Valmont Fashions Ltd. (9390)
Valmont Sweaters Ltd., Meek Knit Ltd.,
M.N.S. Printing Ltd

Plot#928,923 AZIZ Complex, Vogra, Joydepur, Garzipur
(+ 23.981214N,90.380281E)

28.MAY.2014

Identified Priority 2 Concerns

1st Priority 2 Concern

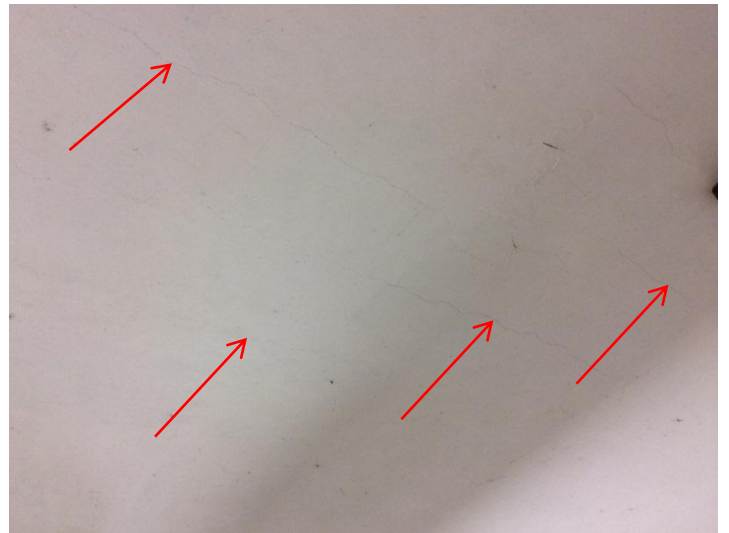
Cracks appeared underside slab on 4th - 6th floor level, capacity check is required prior to repairing.

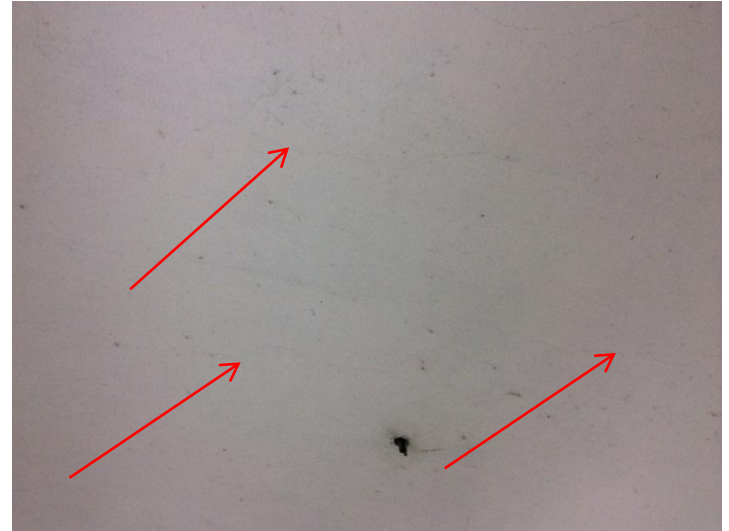
Uncontrolled heavy storage on ground floor. .
The apparent live load is believed to be 5.0 kPa.
Loading plan needs to be implemented.

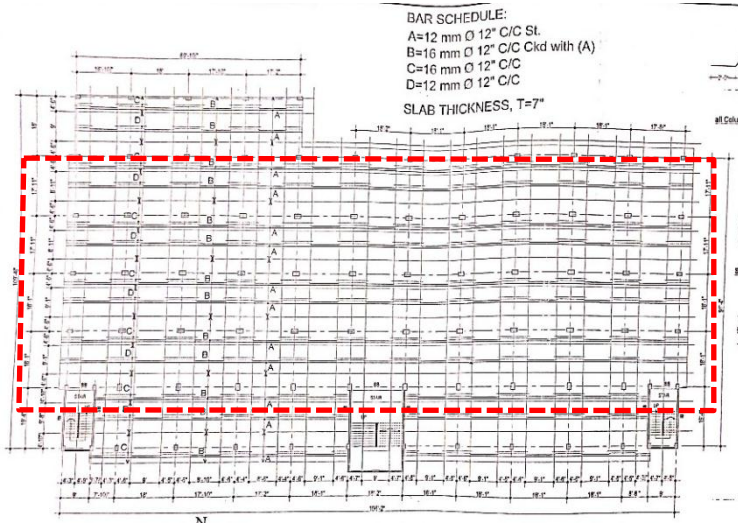
There is no structural drawings provided and insufficient lateral steel bracing. Capacity check is required.

4th Priority 2 Concern

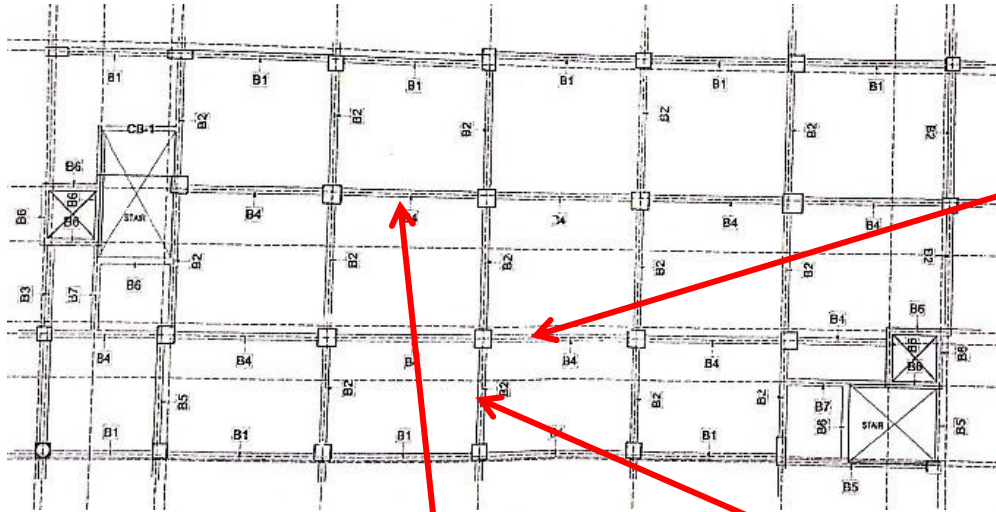
There are no R.C. beam on 1st to 4th floor levels and these do not match structural drawings. Capacity check is required.
